**KNOXVILLE HISTORIC ZONING COMMISSION
STAFF REPORT - CERTIFICATE OF APPROPRIATENESS APPLICATION**

PROPERTY ADDRESS: 1621 Jefferson Ave 37917

FILE NO.: 9-C-15-HZ

MEETING DATE: 9/17/2015

Back view_left:
Remove door
and windows_all
non-original.

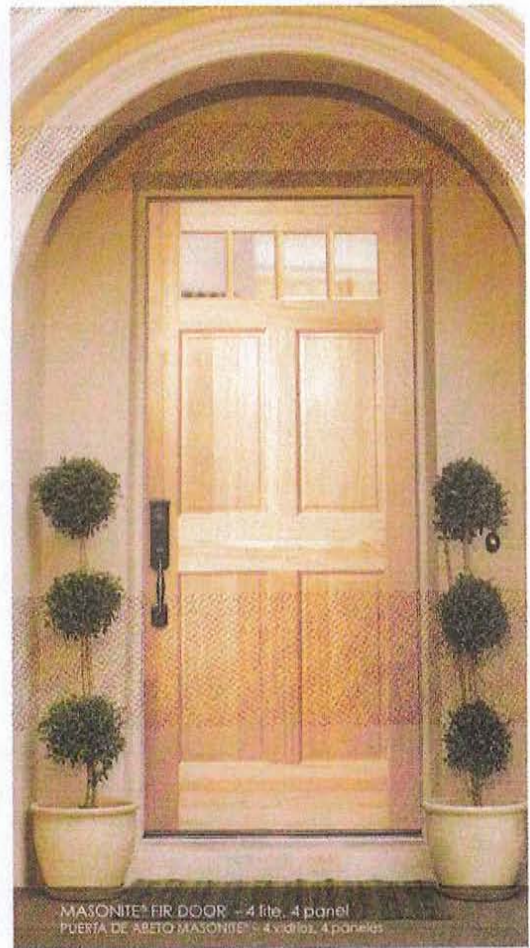
Replace
windows with a
set of full-light
french doors.
